## SAFETY ADVISORY # 19-361

### Cougar Solar Prep 40-Amp Mini Breaker Wiring

**Fig. 1**

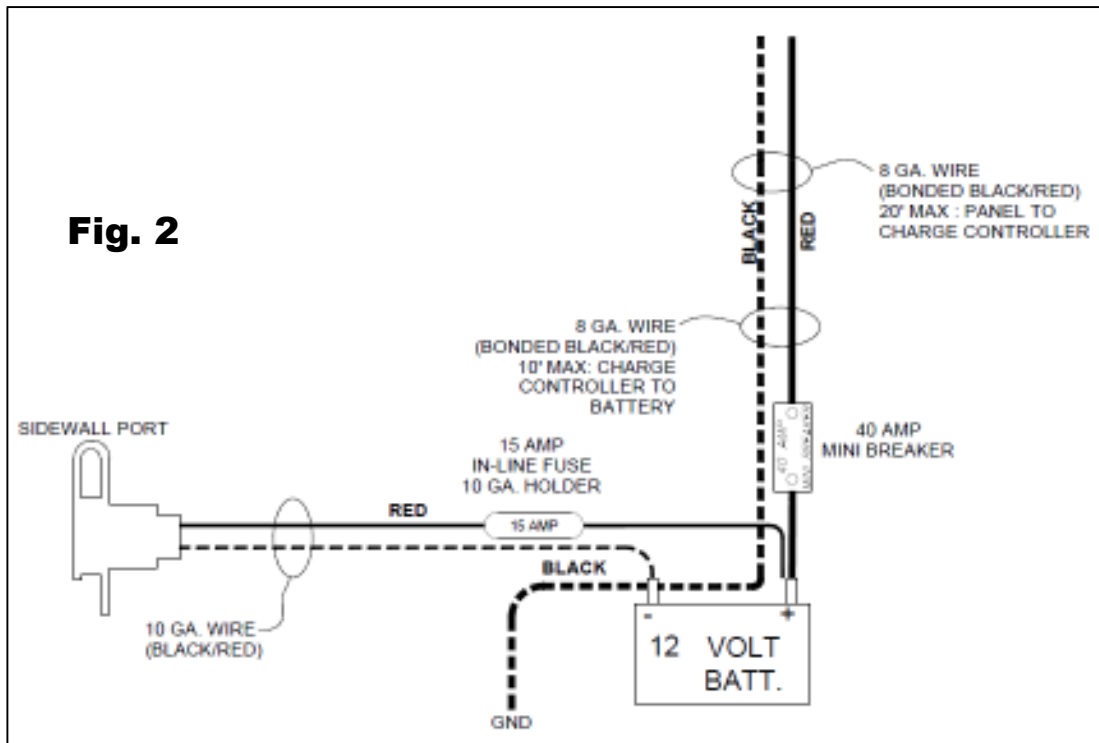
Keystone is conducting a voluntary RECALL notification campaign in accordance with the National Highway Transportation and Safety Act. It has been decided that the wiring to the 12V breakers located by the battery may not be connected to the protected side of the breaker. If this condition exists it will lead to an increased risk of fire if an electrical short should occur on the unprotected circuit.

Visually inspect the wiring at the 40-amp breaker. The solar prep wire is a red 8-gauge wire with purple ring terminal. The red 8-gauge wire to the solar prep should be mounted on the line (protected) side of the breaker, this is the opposite terminal of the battery cable. Re-mount the wiring if needed. See Figures 1 & 2

The remedy is to inspect the installation of the Solar Prep wiring at the circuit breaker mounted close to the battery and re-mount the wiring if needed.
